# Hunterdon County Department of Health

April 8, 2022

Re: Septic System Alteration Waiver  
Municipality: Clinton Township  
Block: 1 Lot: 22  
Location: 24 Deer Hill Road

WAIVERS:  
-LESS THAN 48" ZONE OF DISPOSAL IN PASSING SOLES.

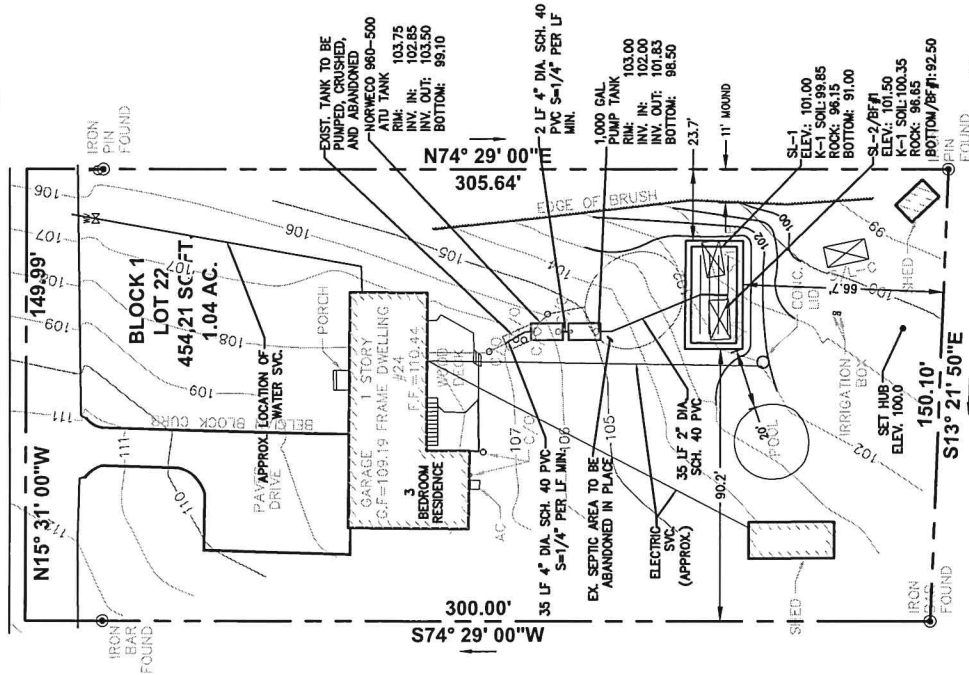
1. The horizon that the passing soil permeability test was performed in was only 30 inches in thickness, which does not meet the minimum 48 inches required in the Zone of Disposal. The engineer shall explain the soil testing on the property and provide testimony that this is the best design to address this issue.
